Engineering Note: EN0086 Hydro-Control V Sensor Communication Drop-Outs

Summary: Hydro-Control V and HS0089 v1.13 Sensor firmware Communications Issues

Products affected: Hydro-Control (HC05), Hydro-Mix (HM07), Hydro-Probe Orbiter (ORB02)

Revision Date: 07/07/16

Figure 1: HC05 Sensor Drop-Out

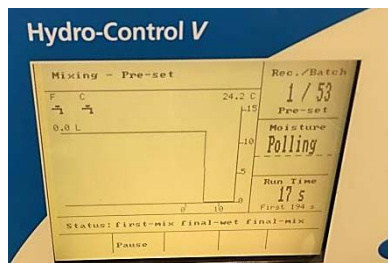
Sensors utilising firmware HS0089 v1.13 (HM07 and ORB2) are not fully compatible with the Hydro-Control V unit, as this version of firmware has the potential for communication issues with the HC05. All other versions of Hydronix sensor firmware are unaffected.

The communications failures are due to a small change in the delay time to a protocol request (potential increased delay). The potential increase in the delay time can cause some messages to be missed by the HC05 resulting in a sensor drop-out (Figure 1).

If a sensor with HS0089 v 1.13 is connected to a HC05 it is necessary that the firmware is downgraded to HS0089 v1.11.
